Access Compliance Report

Public Rights-of-Way

(Curb Ramps)

Intersection ID: 24411	Main Street: CAMAROSS_DR	Cross Street: ELPHIN_CT	Location: S
ADA ID: 87996BDDA68D	Ramp Type: Perp	Initial Pass/Fail: Fail	Overall Compliance: No
Severity Score: 8.75			
Codes/Mitigation Info/Possible Solution		Field Measurements/Component Compliance

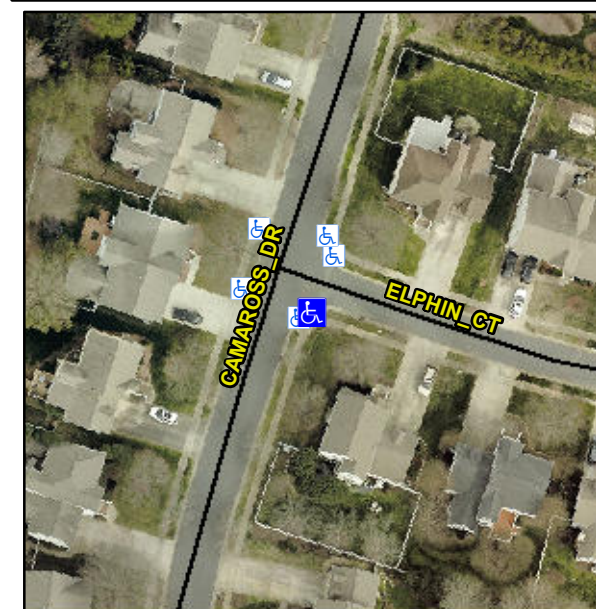
Not Found, R304.5.1

Compliance	Description	Data	Compliance	Description	Data
N/A	Ramp Length (in)	47.0	Yes	Ramp Slope (%)	5.2
No	Ramp Width (in)	47.0	Yes	Ramp XSlope (%)	1.0
N/A	Flare Type LT	N/A	N/A	Flare Type RT	N/A
N/A	Flare Slope LT (%)	N/A	N/A	Flare Slope RT (%)	N/A
N/A	Flare Traversable LT?	N/A	N/A	Flare Traversable RT?	N/A
N/A	Landing Length (in)	N/A	N/A	DWS Provided?	N/A
N/A	Landing Width (in)	N/A	N/A	DWS Contrast?	N/A
N/A	Landing Slope (%)	N/A	N/A	DWS Length (in)	N/A
N/A	Landing X Slope (%)	N/A	N/A	DWS Full Width?	N/A
N/A	Landing Curb? (Y/N)	N/A	N/A	DWS Offset (in)	N/A
N/A	Shared Landing?	N/A			
N/A	Gutter Ponding?	N/A	N/A	Gutter Slope (%)	N/A
N/A	Gutter Lip Ht (in)	N/A	N/A	Gutter X Slope (%)	N/A
N/A	Painted X Walk1?	No	N/A	Painted X Walk2?	N/A
	X Walk 1 Direction	To NE		X Walk 2 Direction	N/A
N/A	X Walk 1 Width (in)	N/A	N/A	X Walk 2 Width (in)	N/A
	X Walk 1 Slope (%)	2.0		X Walk 2 Slope (%)	N/A
	X Walk 1 X Slope (%)	1.9		X Walk 2 X Slope (%)	N/A

Remove & Replace Entire Ramp.
